CMD 24-H5.49

Written submission from the Mississaugas of Scugog Island First Nation

Application to extend the operation of Pickering Nuclear Generating Station Units 5 to 8 until December 31, 2026

Intervenor Submission: Ontario Power Generation (OPG)-Pickering Nuclear Generating Station (PNGS)

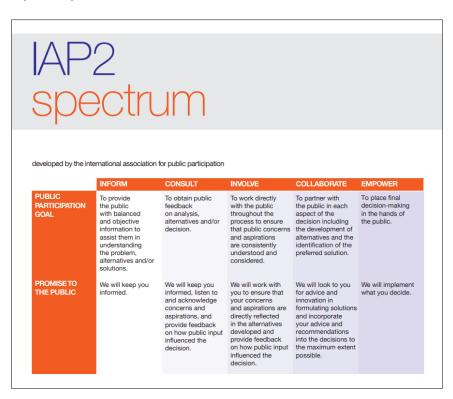
Our understanding of collaborative planning is rooted in the International Association for Public Participation's (IAP2) spectrum of public participation (see figure below). Collaborative planning requires OPG to partner with MSIFN in each aspect of its decision-making process for major projects and the operation of major facilities, including the development of alternatives and the preferred solutions. Collaborative planning also means OPG looking to MSIFN for advice and innovation in formulating solutions, and incorporating MSIFN's advice and recommendations into its decisions to the maximum extent possible. OPG has demonstrated, on occasion, that it is interested in true collaborative planning with MSIFN, and needs to enshrine such collaborative planning in its corporate policies.
